# SERVICE RECEIVED LETTER

No. 564

Revised Hartzell Propellers

Service Letter No. 62

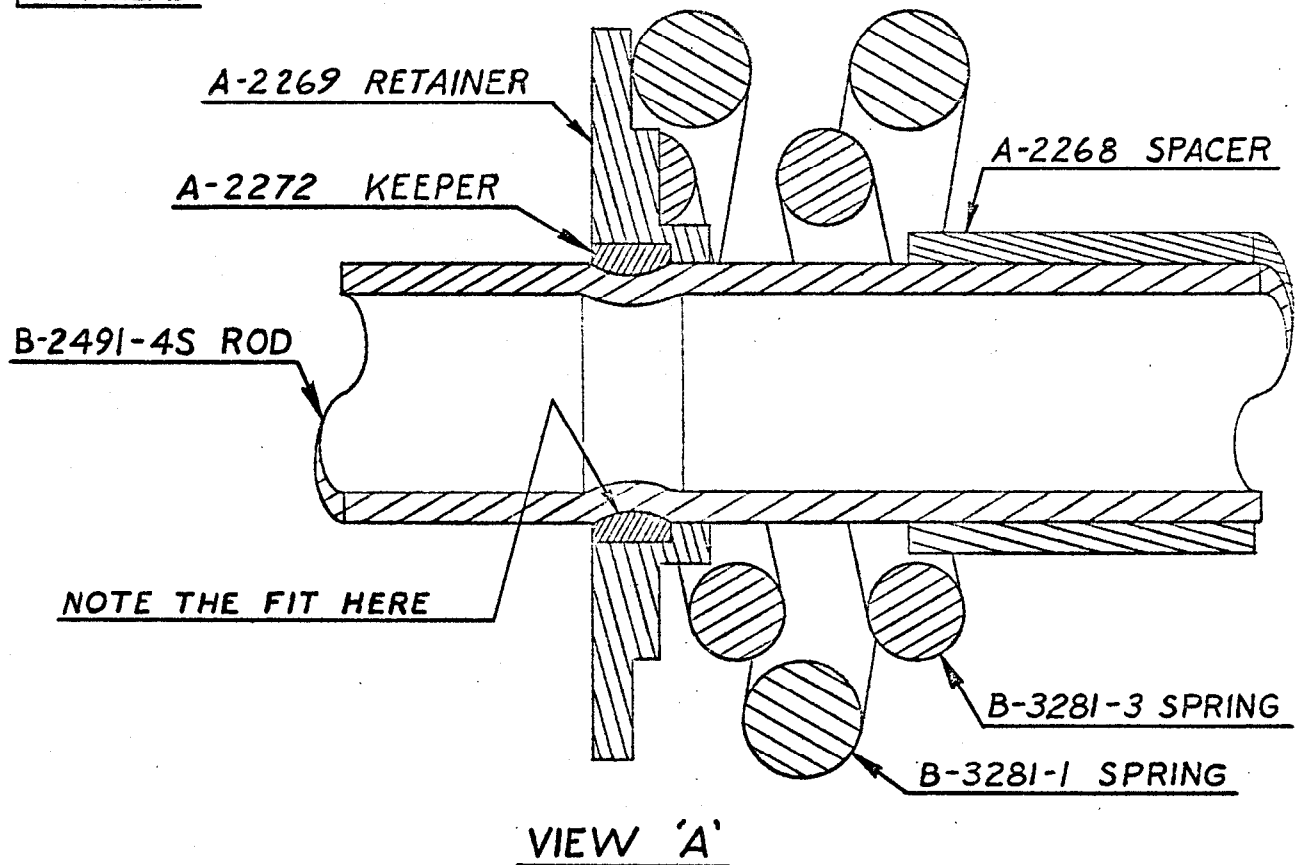
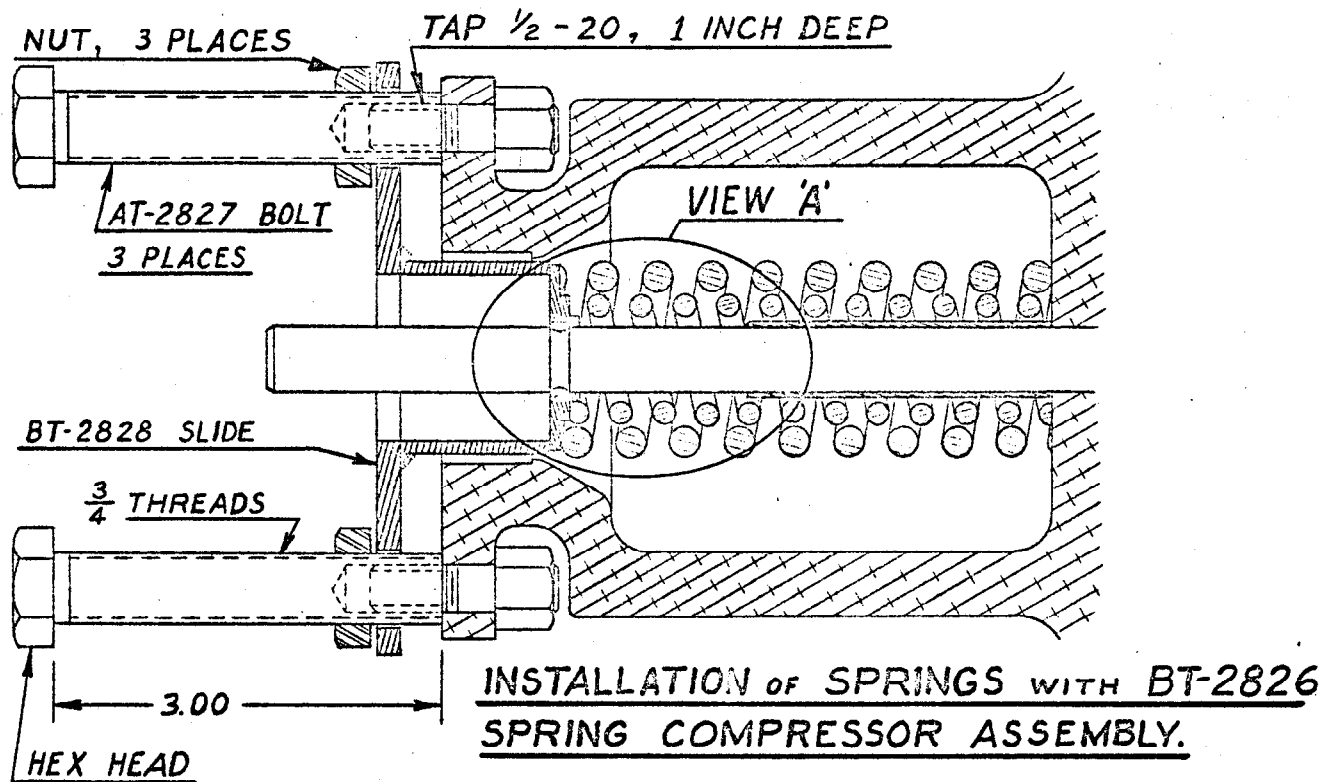
- 4) Install the spring kit in the extension shaft cavity, as shown in the following sketch, as follows:
  - (a) install A-2268 spacer on the B-2491-4S rod
  - (b) install the B-3281-1 and -3 springs over the spacer
  - (c) install the A-2269 retainer as shown
  - (d) compress the springs with special spring compressor, P/N BT-2826
  - (e) install A-2272 keeper in the groove formed in the B-2491-4S rod, as shown in the enlarged sketch
  - (f) remove spring compressor, allowing the springs to bear against the A-2269 retainer
- 5) Unfeather the blades with pressure applied through B-2491-4S rod, or by means of blade arms applied to both blades.
- 6) Recharge the cylinder with dry air or nitrogen to:

70 PSI @ 70° F. for the HC-E2YK-2RB	}	PA-23-250
70 PSI @ 70° F. for the HC-E2YR-2RB		PA-E23-250
50 PSI @ 70° F. for the HC-E2YL-2B		- PA-30 and PA-39
- 7) Install new table of pressures inside the spinner cap in place of the old decal, and also on propeller cylinder. Decals are included in the A-2273 kit. Also install CA-003 decal on spinner near air valve.
- 8) Add the letter "S" after the hub dash number, which is located on the side of the hub, as: HC-E2Y( )-2( )BS. Use a steel stamp.
- 9) For the PA-30 and PA-39 aircraft, remove the spring assembly which is located inside of the engine crankshaft. The parts consist of: A-2488 sleeve, 9-2410-31 spring, A-2487 thimble, and A-2496 shim. These parts are not required after the A-2273( ) spring kit is installed.
- 10) Install the propeller onto the engine crankshaft in accordance with appropriate installation instructions.
